**CHANGE ORDER REQUEST SUMMARY**

PROJECT : Spring Lake Park City Hall Renovation / Expansion

# Proposal Request

PROPOSAL REQUEST NO: 10  
DATE: 7/15/2024  
PROJECT NO: 193806049  
CONTRACT FOR: Building Construction

SURVEY	
DRAWN	NNG
DESIGNED	NNG
CHECKED	JLR
APPROVED	
PROJ. NO.	193806049
SHEET NUMBER	P202

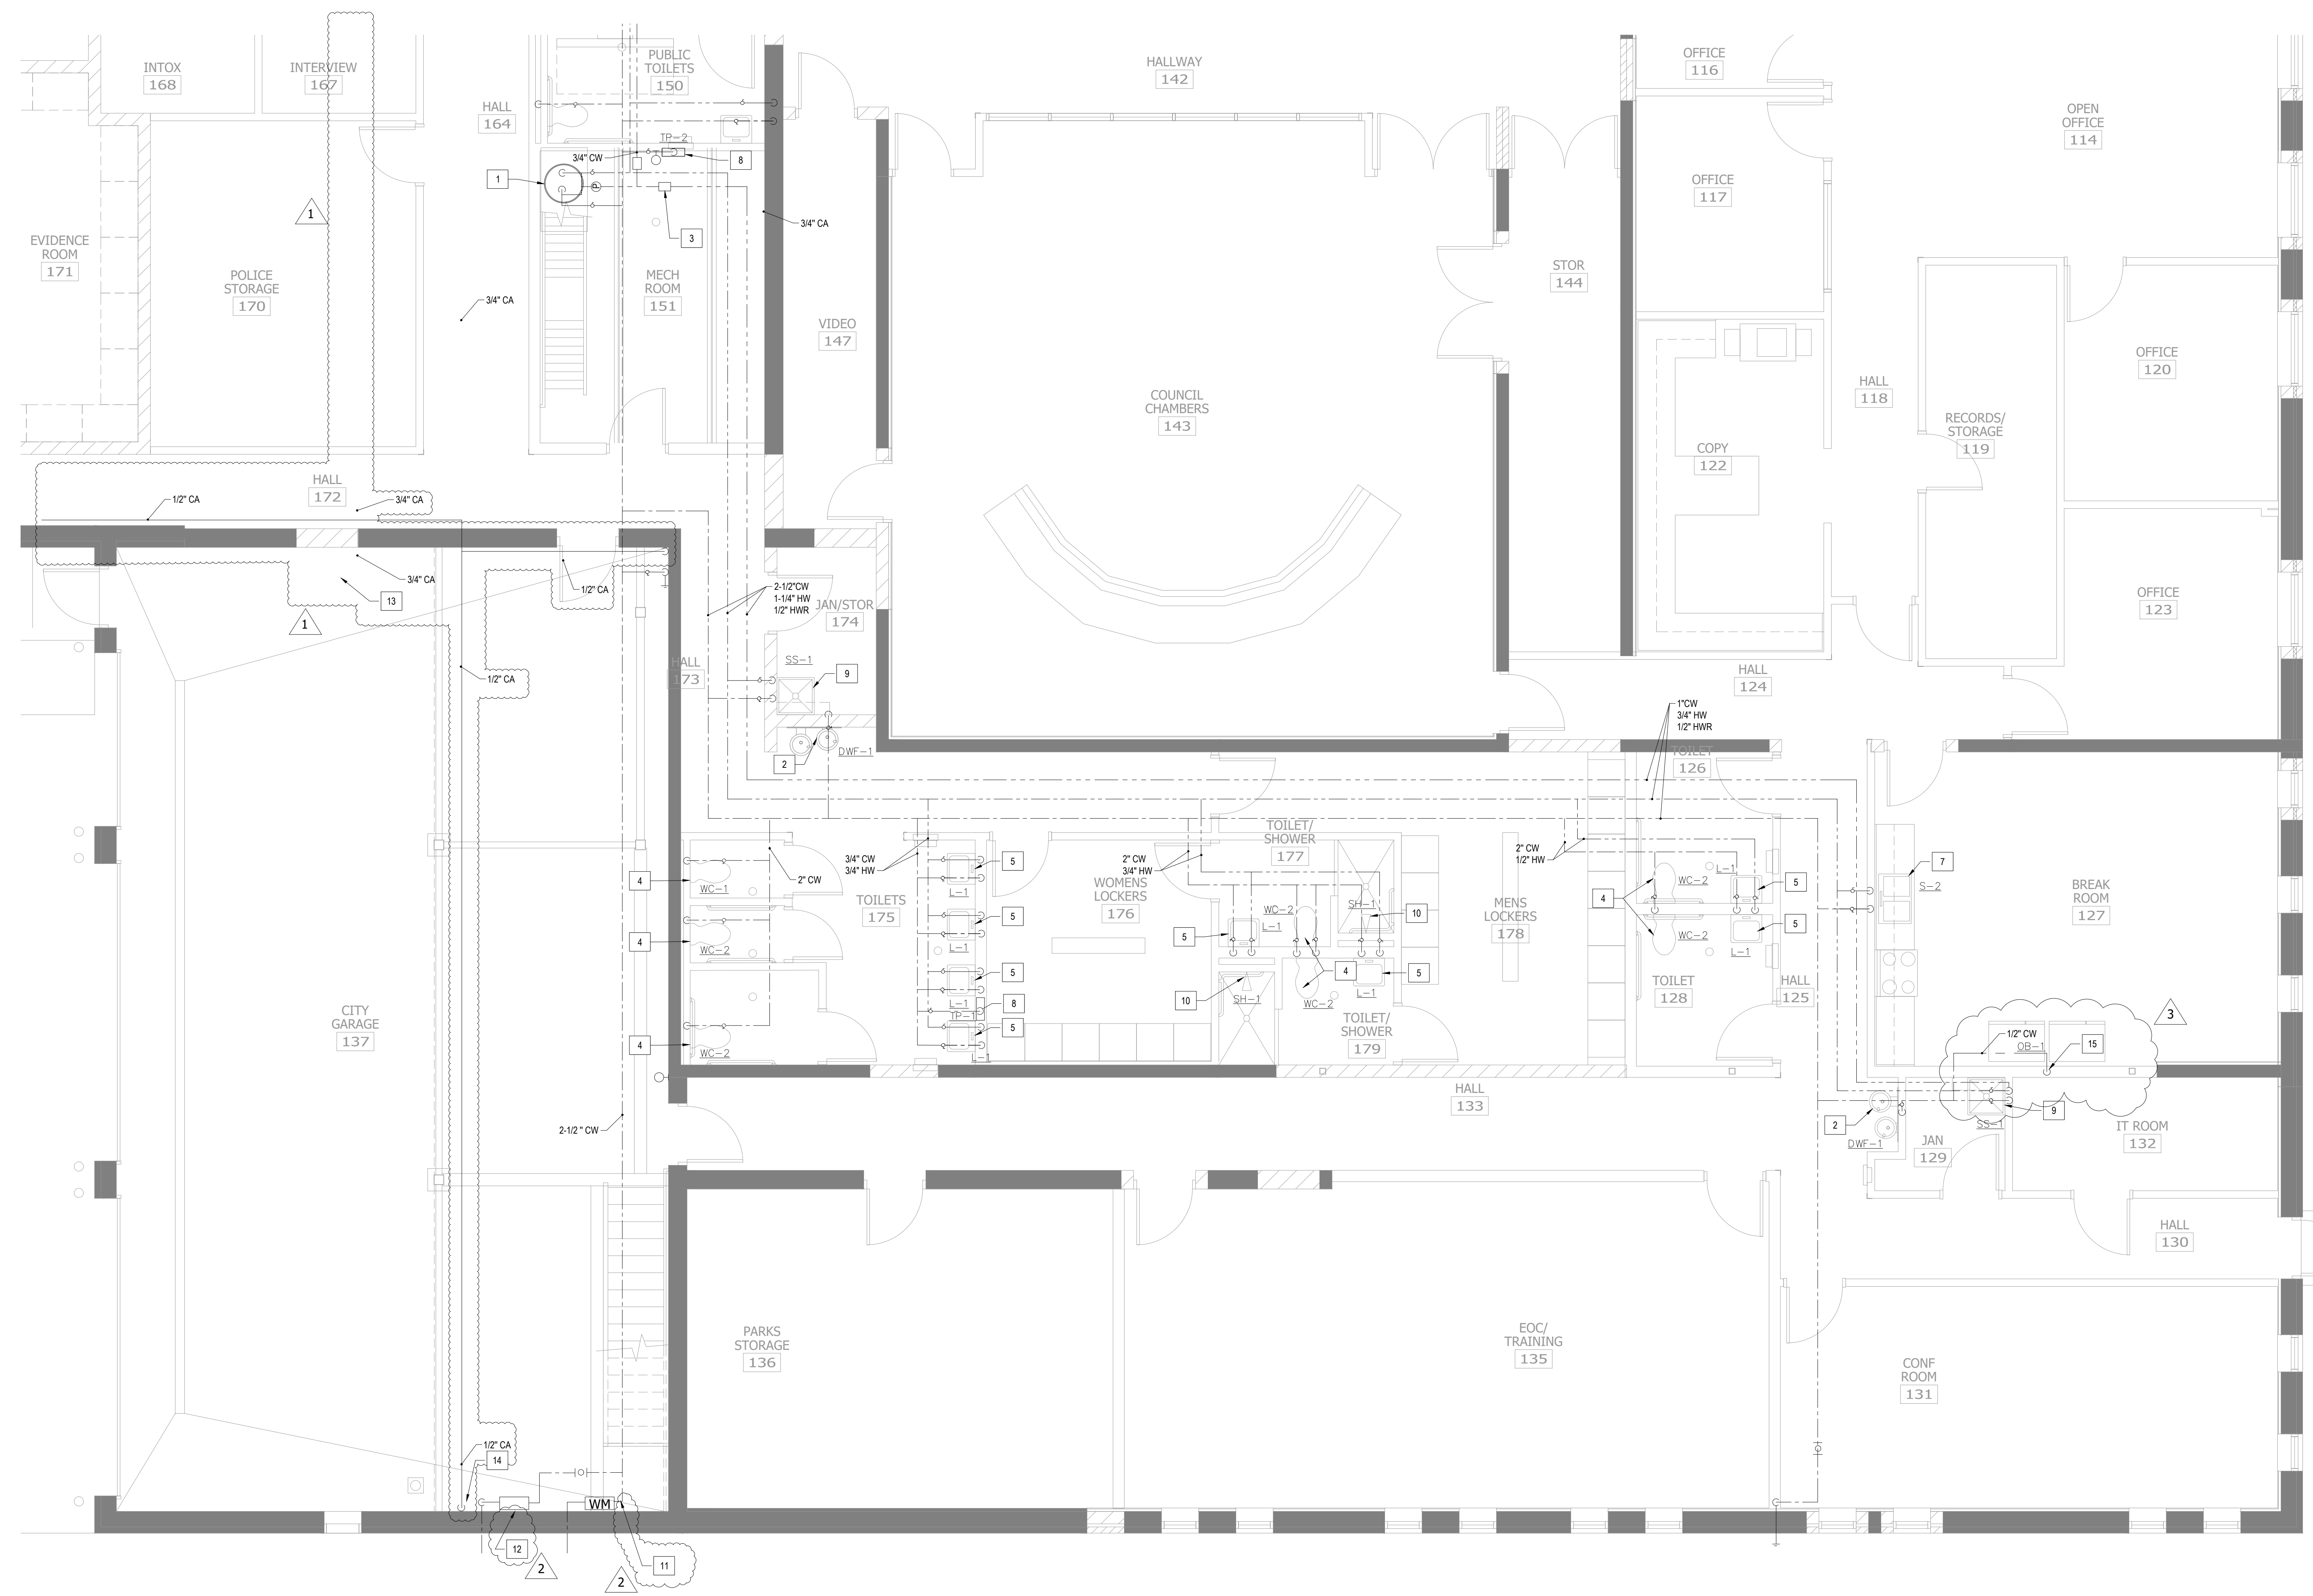
1. Revise plan to show recessed water outlet box in west wall of Break Room 127 as indicated.

SURVEY	
DRAWN	KSL
DESIGNED	KSL
CHECKED	MTF
APPROVED	MTF
PROJ. NO.	193806049
SHEET NUMBER	E302

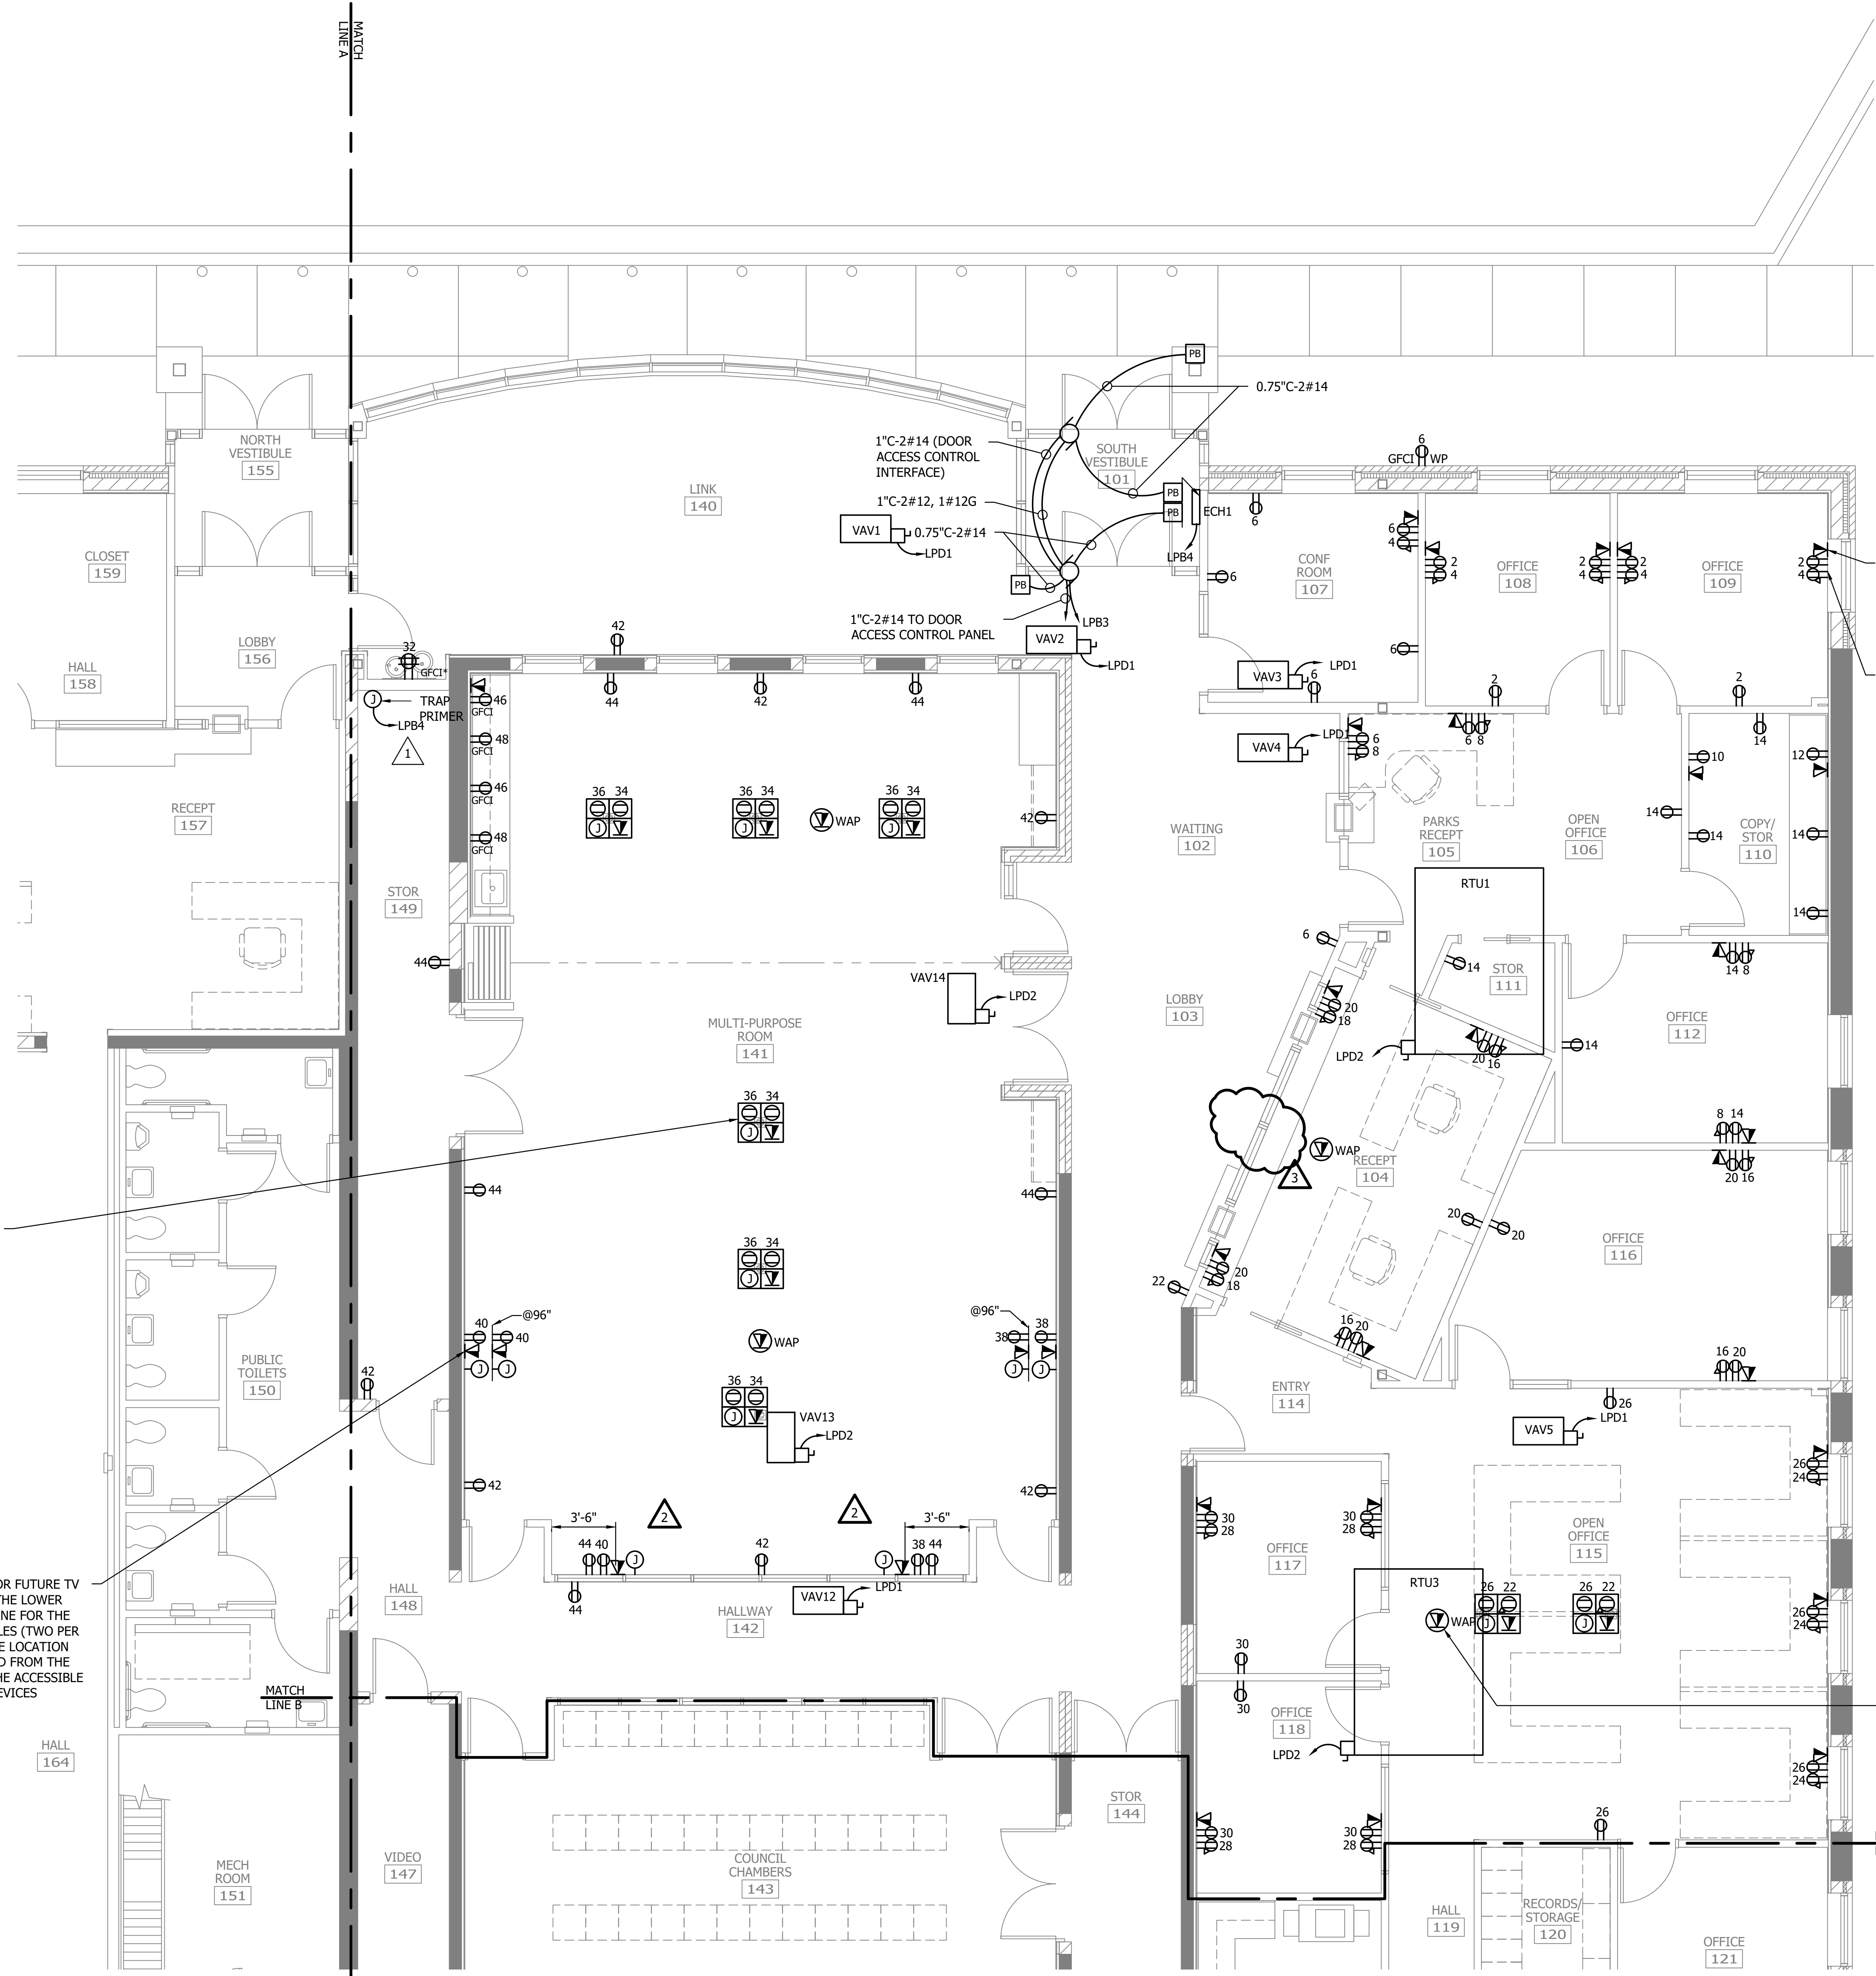
1. Delete power and data receptacles in the center of the service window above counter in Reception 104 as indicated.

SURVEY	
DRAWN	KSL
DESIGNED	KSL
CHECKED	MTF
APPROVED	MTF
PROJ. NO.	193806049
SHEET NUMBER	E402

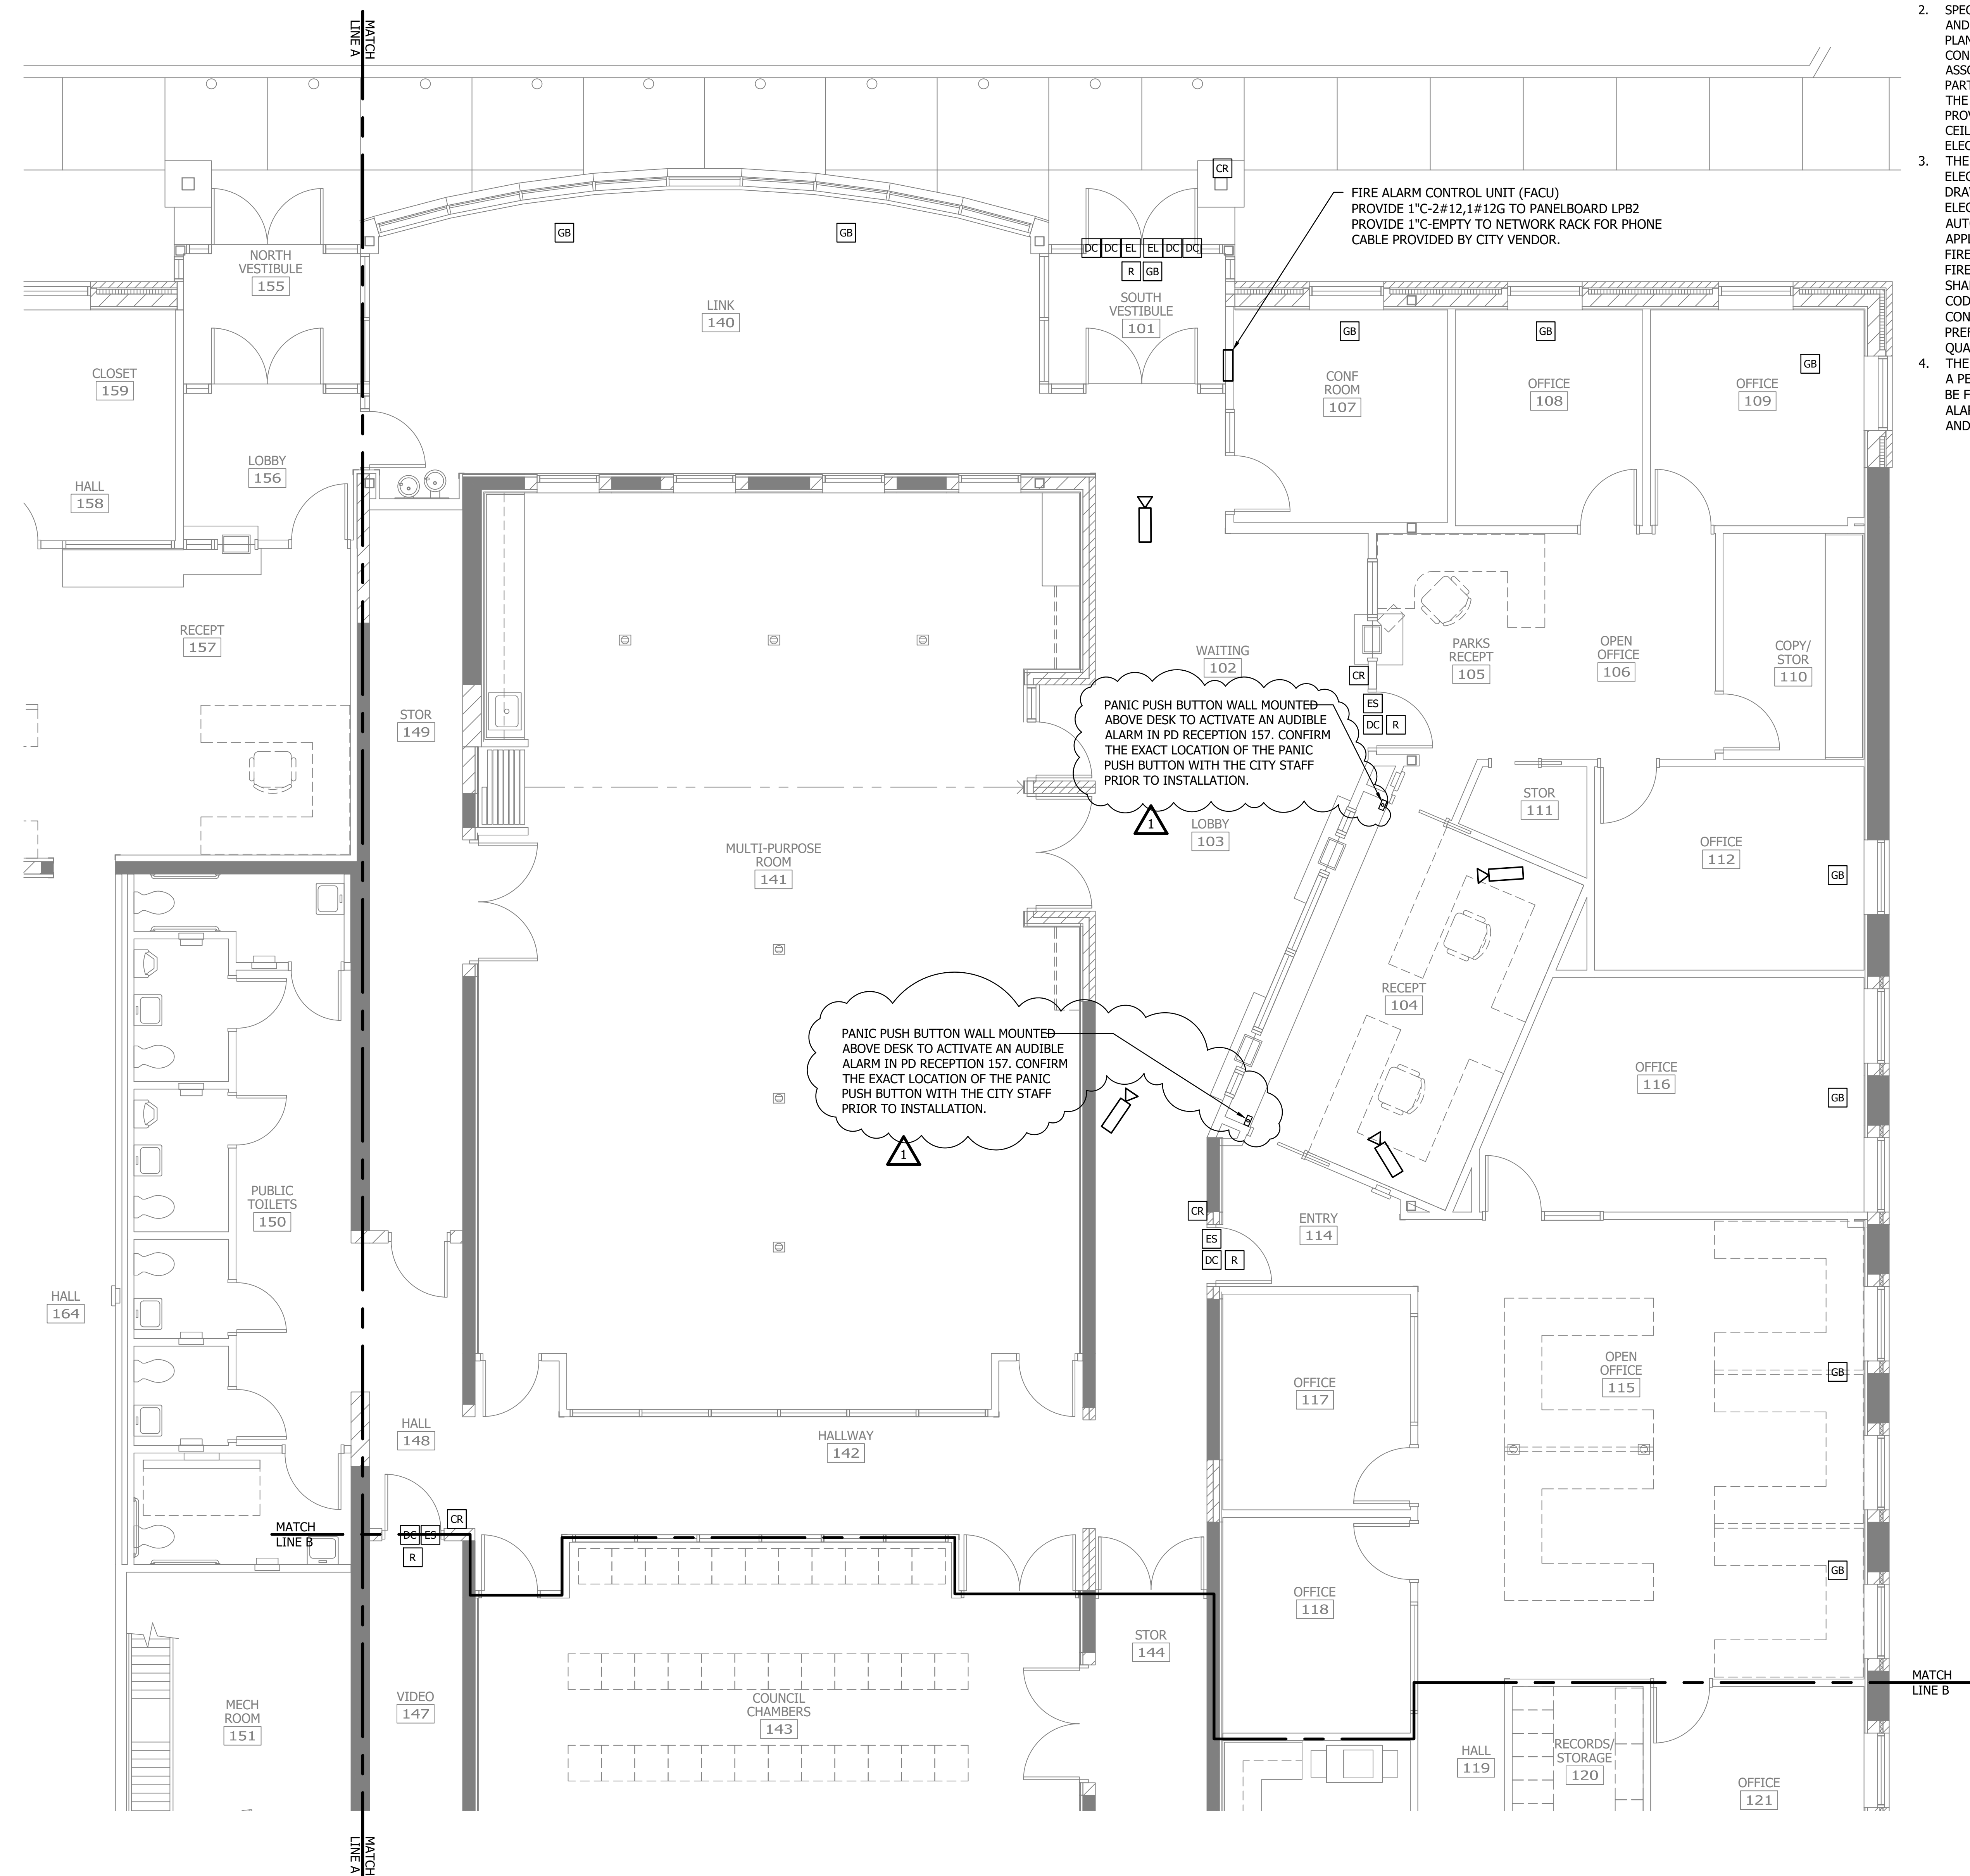
1. Revise plan to add wall-mounted panic buttons above the counter in Reception 104 as indicated.
